VILLAGE OF ROYAL PALM BEACH, FLORIDA

PROJECT NAME: COMMONS PARK PATHWAY LIGHTING  
PROJECT NUMBER: PR1903

**ADDENDUM NUMBER: FIVE**

DATE OF ISSUANCE: September 28, 2021

**NEW SERVICE POINT 'W4' RISER DIAGRAM**  
120/240V, 1PHASE, 3 WIRE

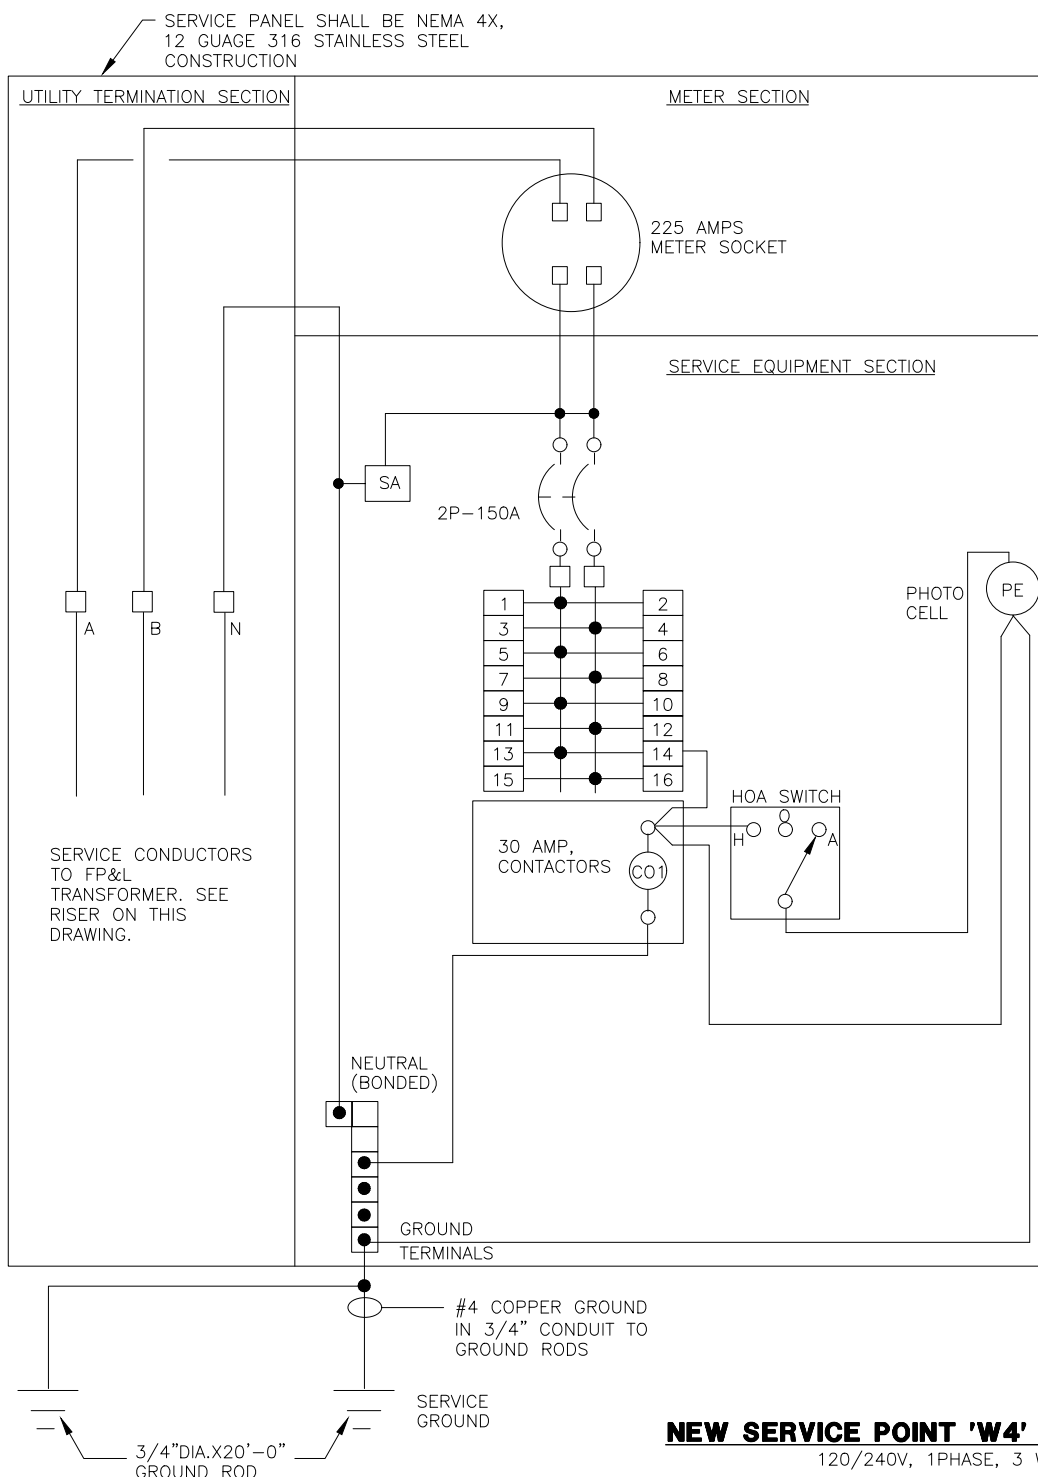
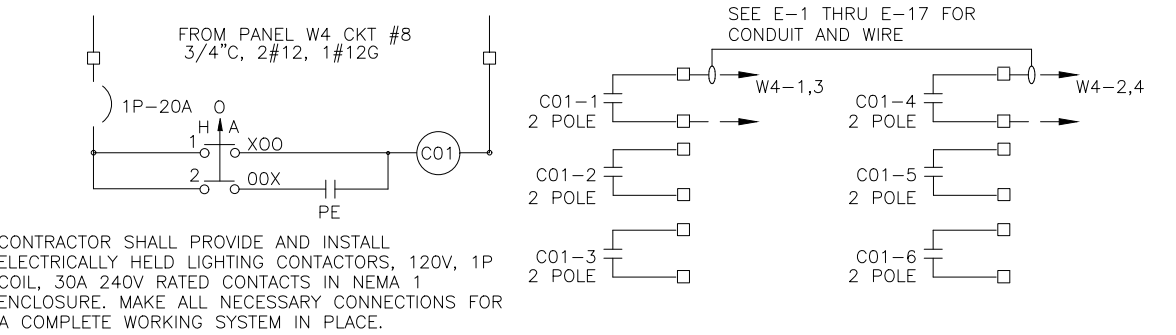
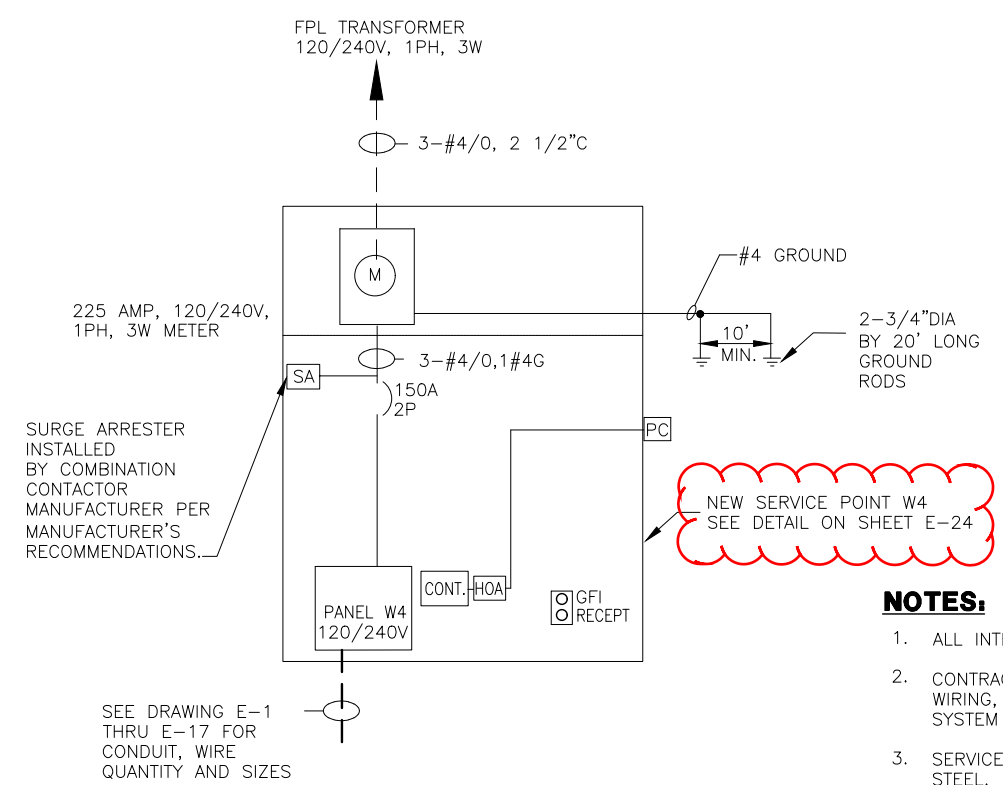
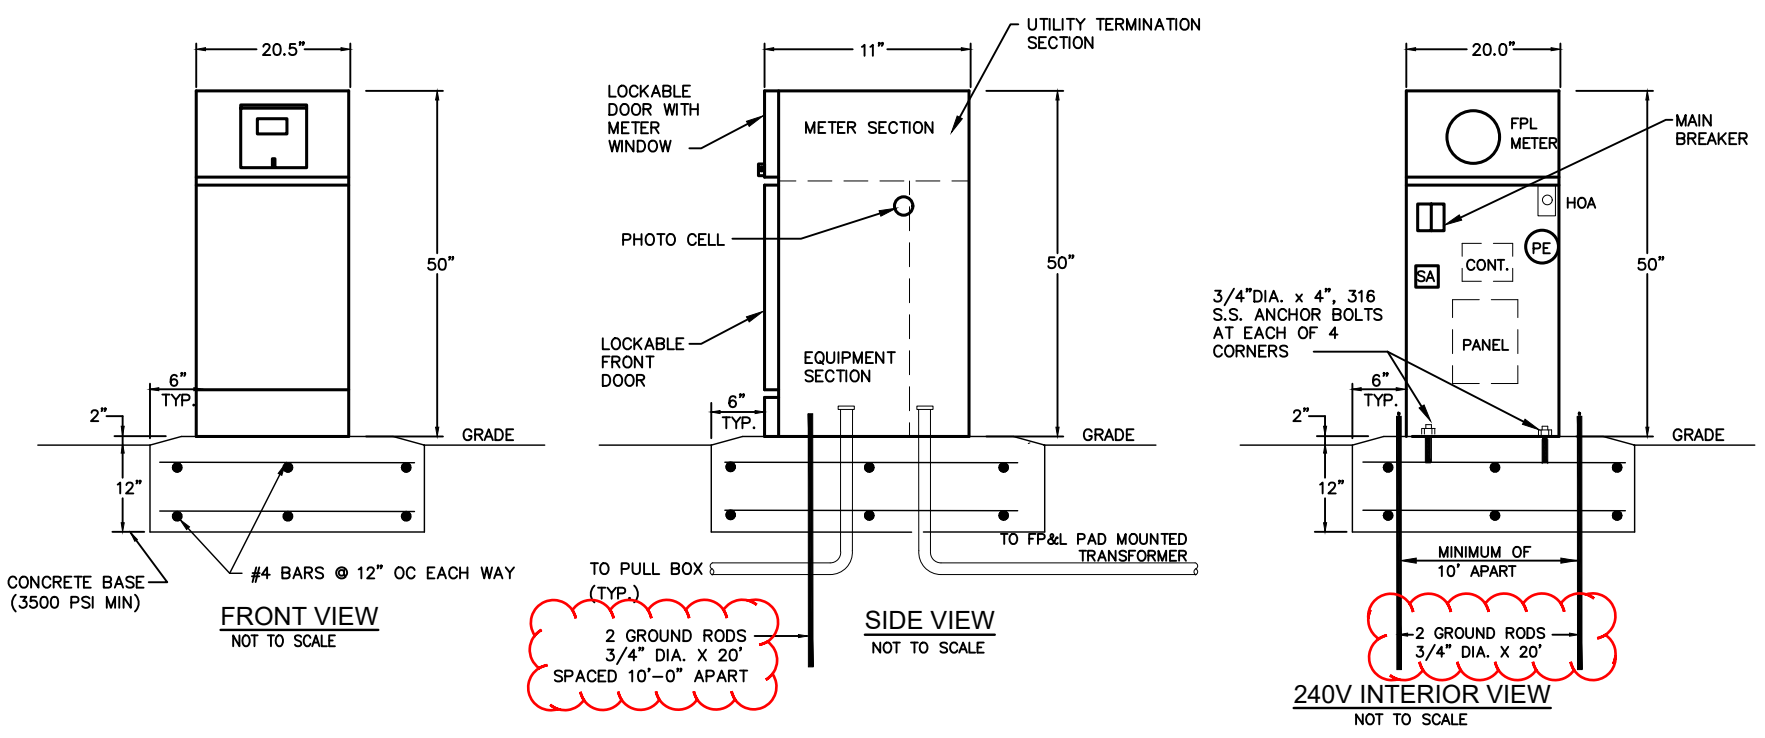
Addendum 5 Revisions:  
Referenced sheet number has been corrected.

**ELECTRICAL PULL BOX DETAIL**  
N.T.S.

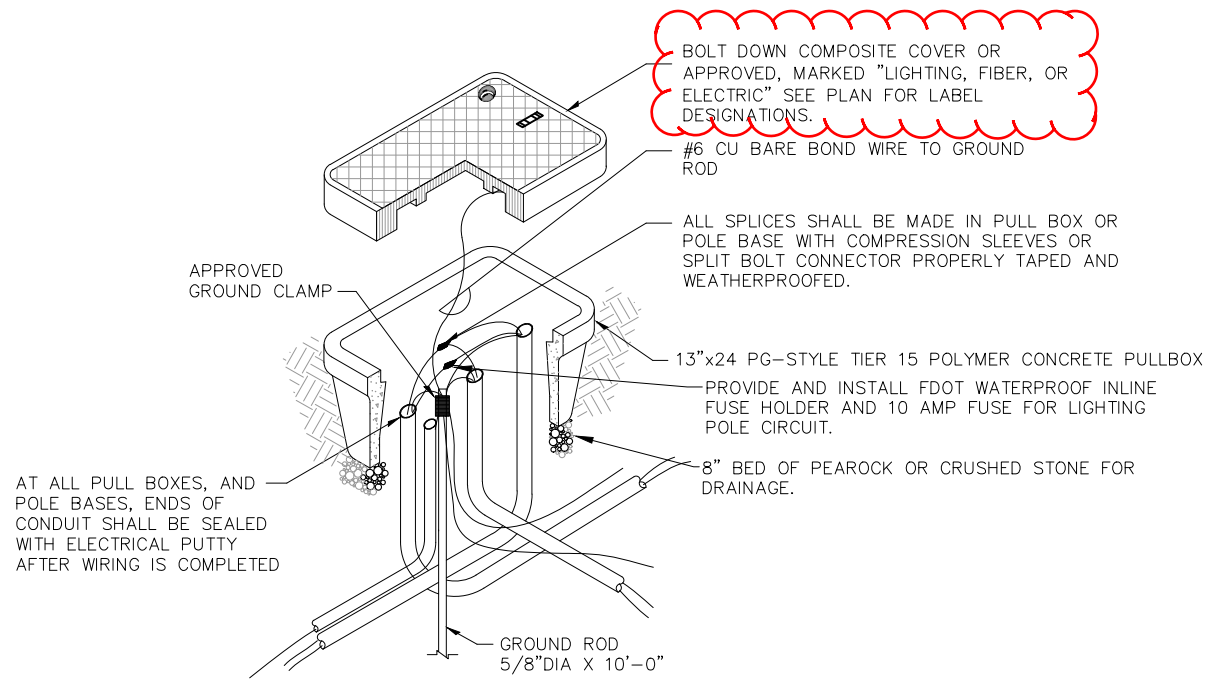
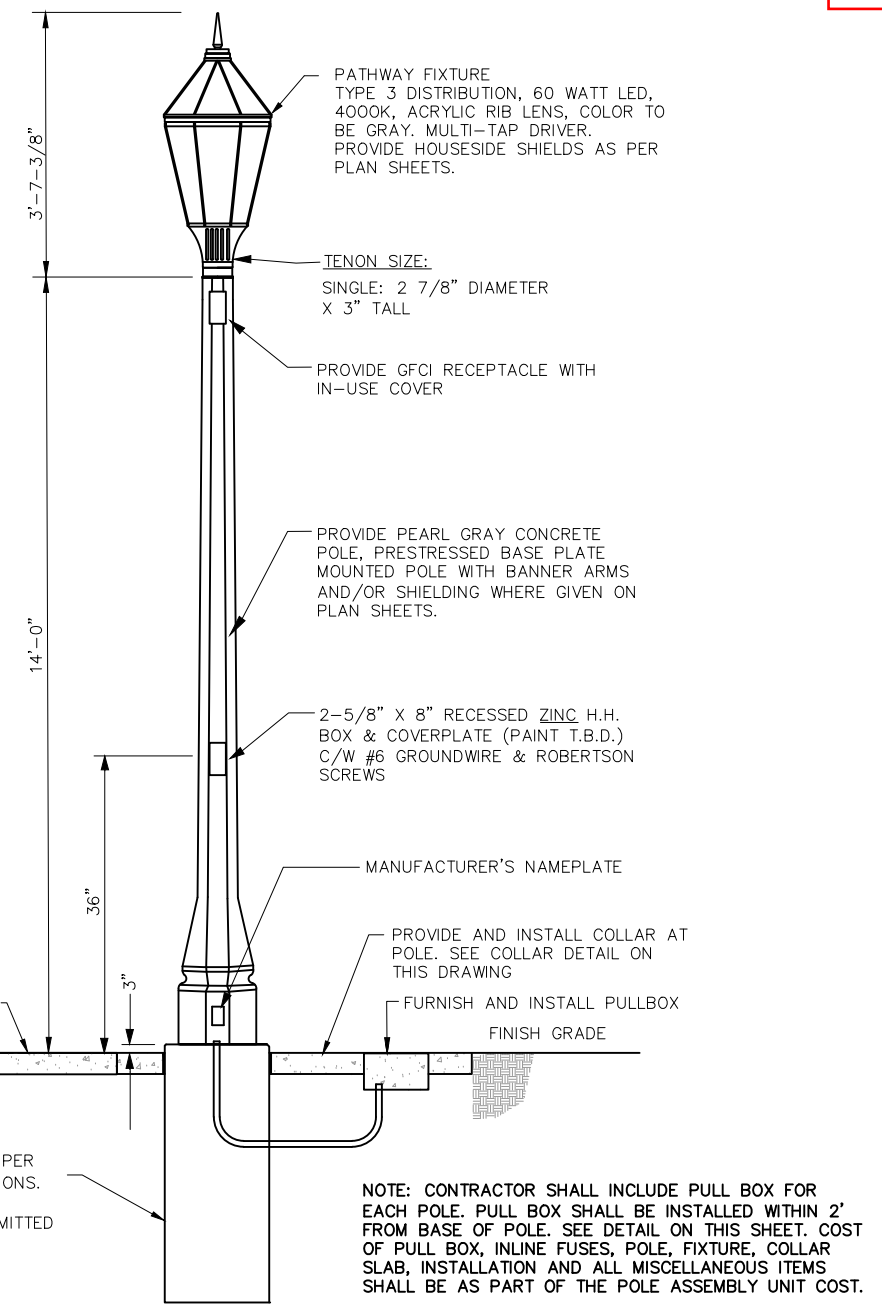
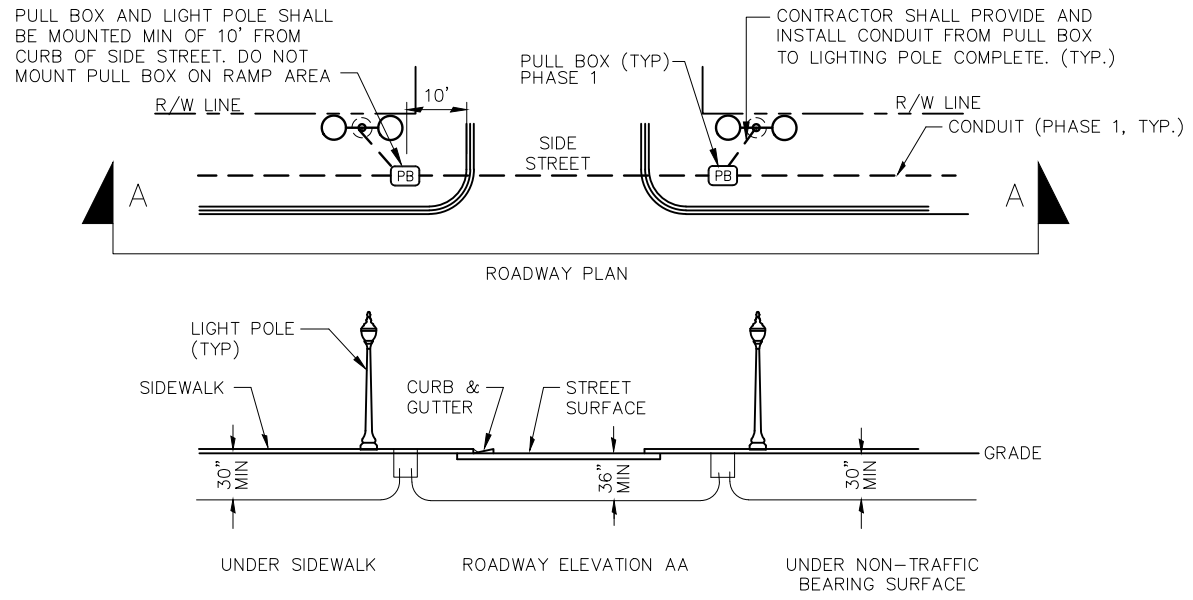
Addendum 5 Revisions:  
Removed references to Auger Pile Detail and Spread Footing. Removed note in pull box detail that required Copper Keeper (this has been changed to an Add/Alt).  
Added electric and fiber labels for pull boxes.
